Product Change Notification / ASER-13ZAYE268

CCB 4902 & 4902.001 Final Notice: Qualification of a new die size and mold compound for Die # 2 for selected catalog part numbers (CPN) ATSAMA5D28C-D1G-CU, ATSAMA5D27C-D1G-CU, ATSAMA5D28C-D1G-CUR, ATSAMA5D27C-D1G-CUR, ATSAMA5D27C-D5M-CU & ATSAMA5D27C-D5M-CUR available in 289L TFBGA (14x14x1.2mm) and U2 component for selected catalog part number (CPN) ATSAMA5D27-SOM1 available in 176L MODULE (40x38x6.34mm) packages.

CCB 4902 & 4902.001
Pre and Post Change Summary
PCN#: ASER-13ZAYE268

Pre and Post Change Comparison - ATSAMA5D27-SOM1

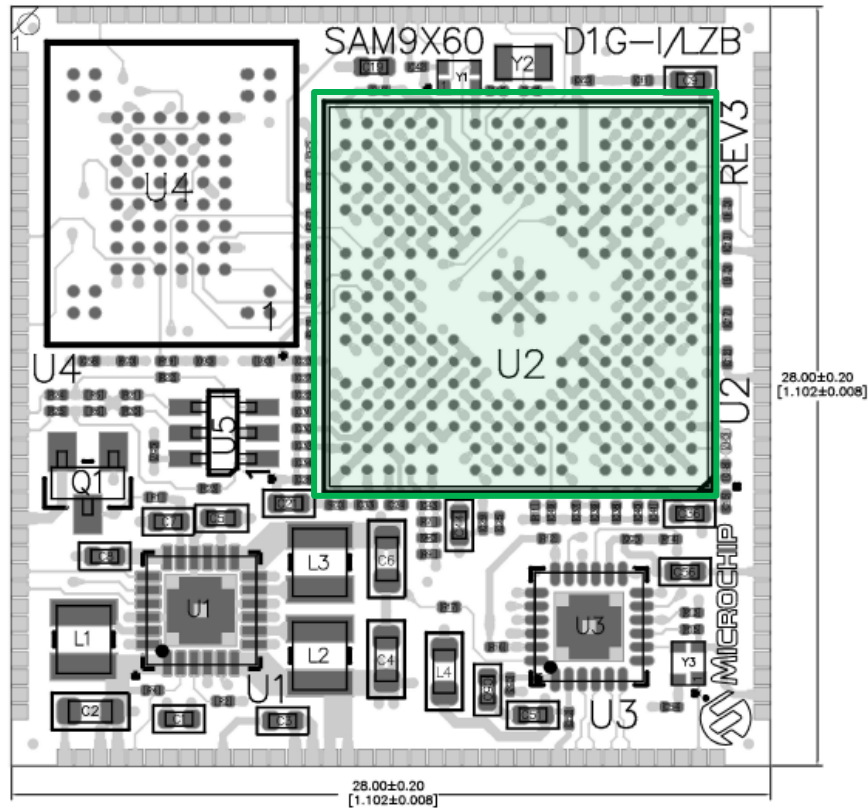
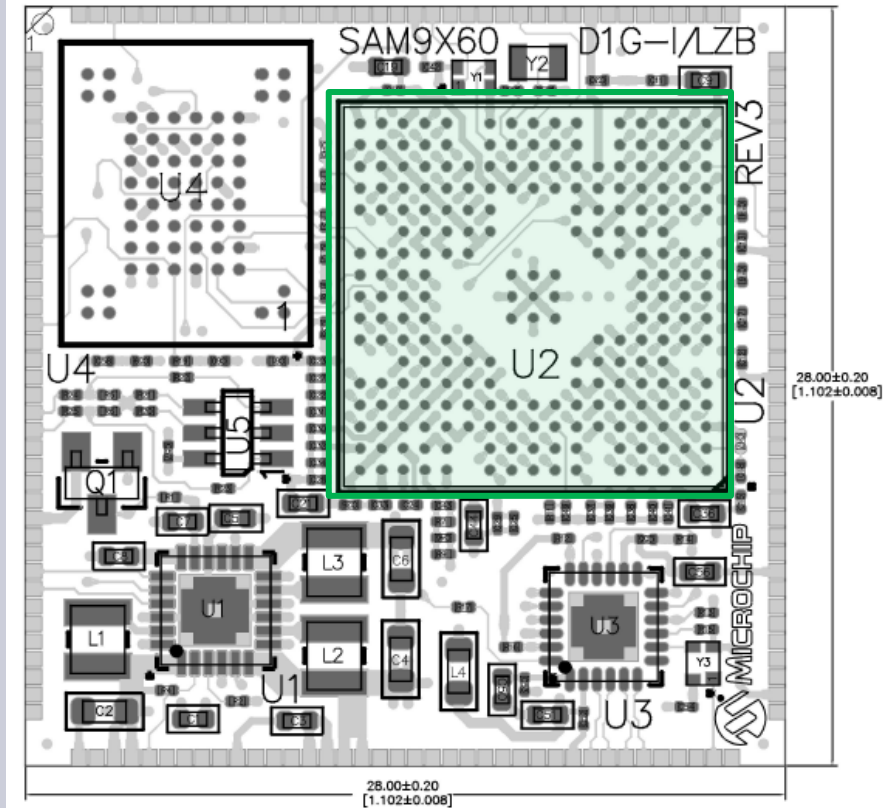
Pre change

Post Change

Pre and Post Change Comparison - ATSAMA5D28C-D1G-CU, ATSAMA5D27C-D1G-CU, ATSAMA5D28C-D1G-CUR, ATSAMA5D27C-D1G-CUR

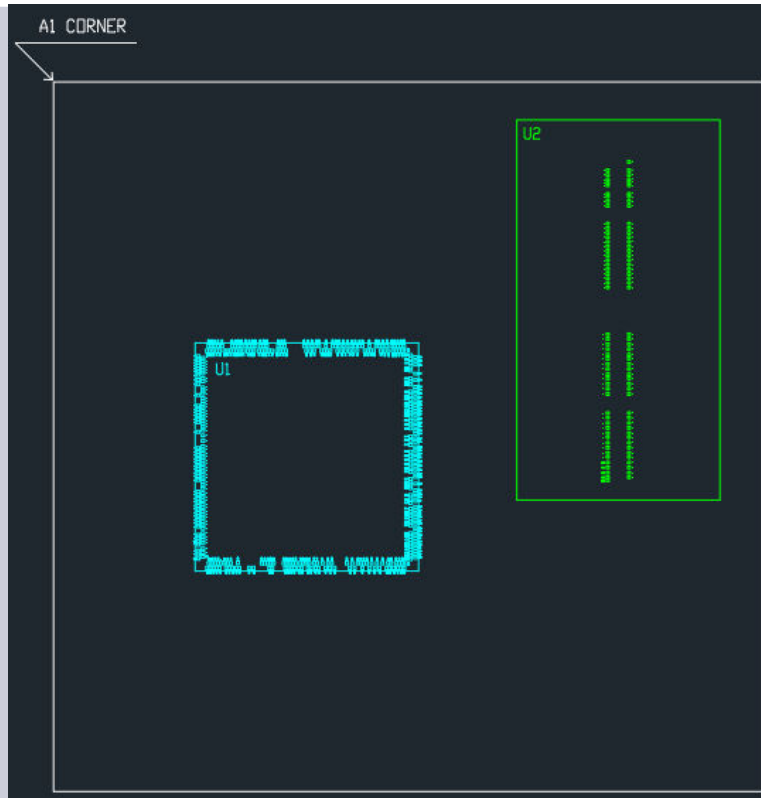
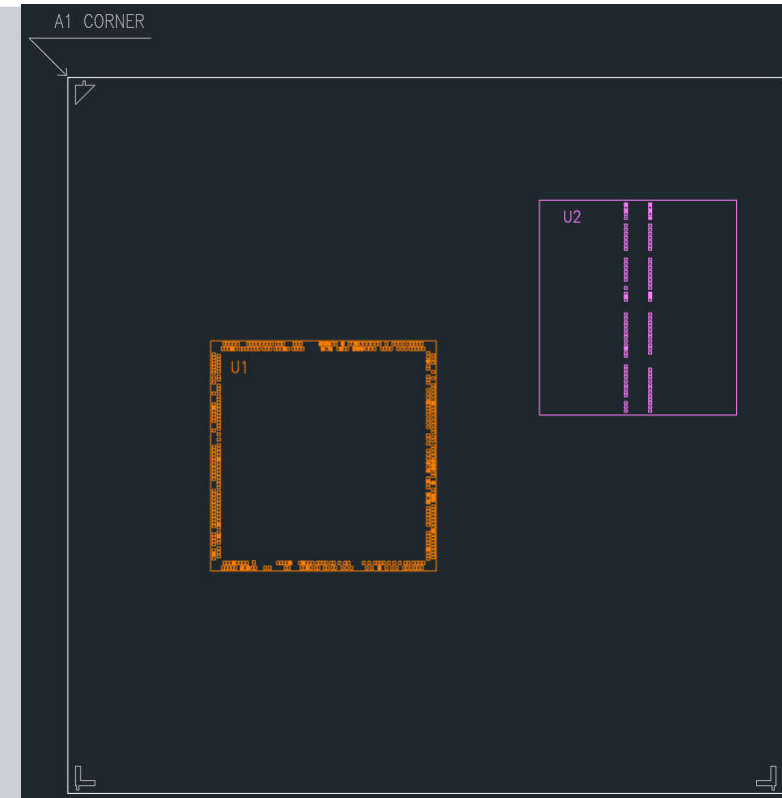
Pre change

U2 size : 153.2x290.6mils

Post Change

U2 size : 150.3x164 mils

Pre and Post Change Comparison - ATSAMA5D27C-D5M-CU, ATSAMA5D27C-D5M-CUR

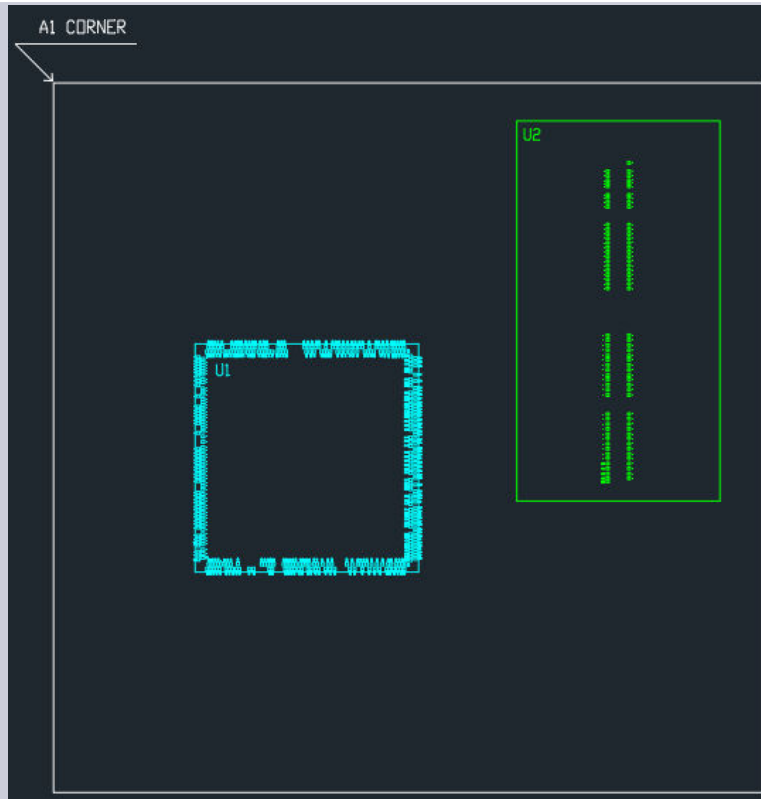
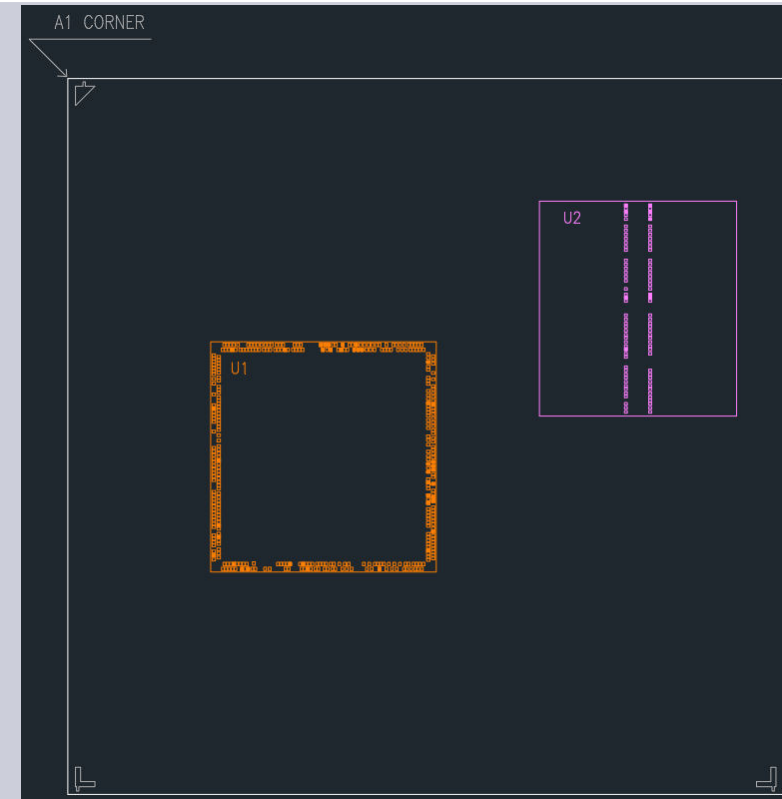
Pre change

U2 size : 160.07x160.7mils

Post Change

U2 size : 109.1x129.6 mils
